[Docket No. 2003-SW-10-AD; Amendment 39-14621; AD 2003-21-09 R1]

Airworthiness Directives; Eurocopter France Model AS355E, F, F1, F2, and N Helicopters

ACTION: Final rule.

Figure 1

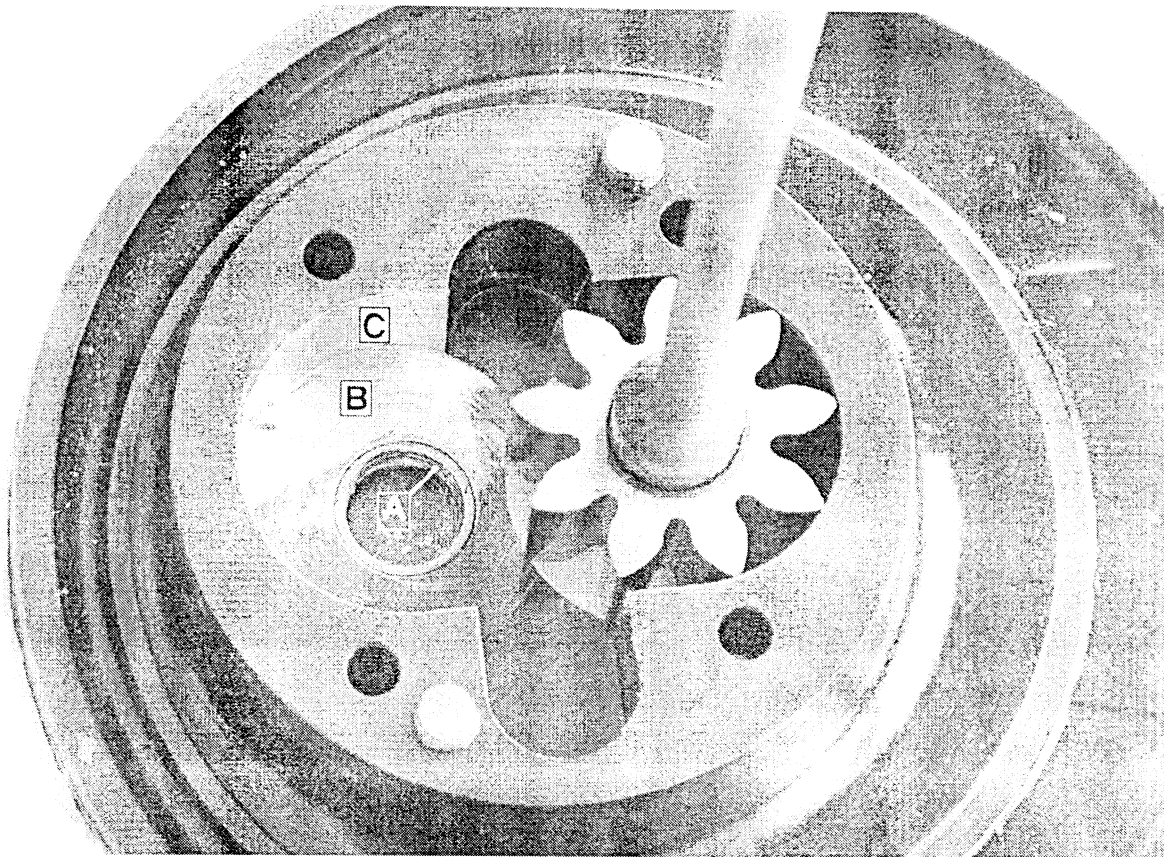
(d) While inspecting the pump, if you find any of the following, replace the MGB and the pump with an airworthy MGB and pump before further flight:

- (1) Crank pin play,
- (2) Out of round bronze bushing (A of Figure 1),
- (3) Offset of the driven gear pinion,
- (4) Metal chips, or
- (5) Wear (C of Figure 1).

Note 2: If wear is present in the B area only as depicted in Figure 1, replacing the MGB and the pump is not required.
